NEWMAR CORPORATION

PRODUCT INFORMATION BULLETIN

DATE ISSUED	MODEL YEAR(S) AFFECTED	PIB #
10/23/2018	2018, 2019	533

Plenum Modification Procedure for New Aire Coaches with Bedroom Low Air Flow Complaint

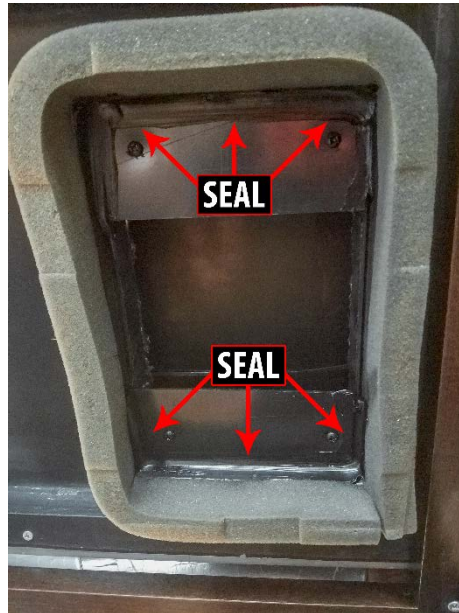
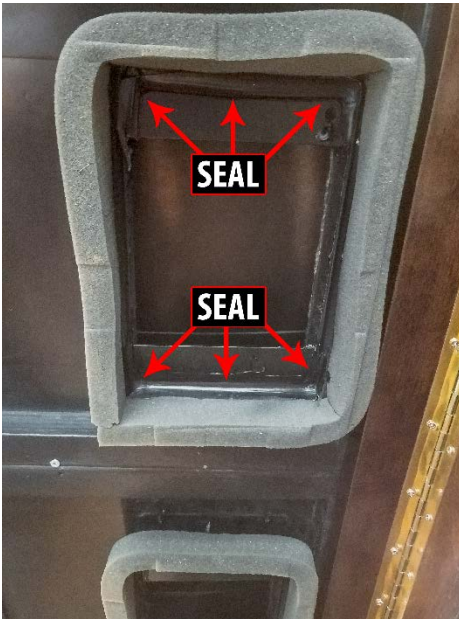
1. Prep the angle pieces to be mounted. Drill one 3/16" hole in each end of the narrower side of the angle. Each hole should be centered and approximately one inch from the end of the angle piece (as shown).
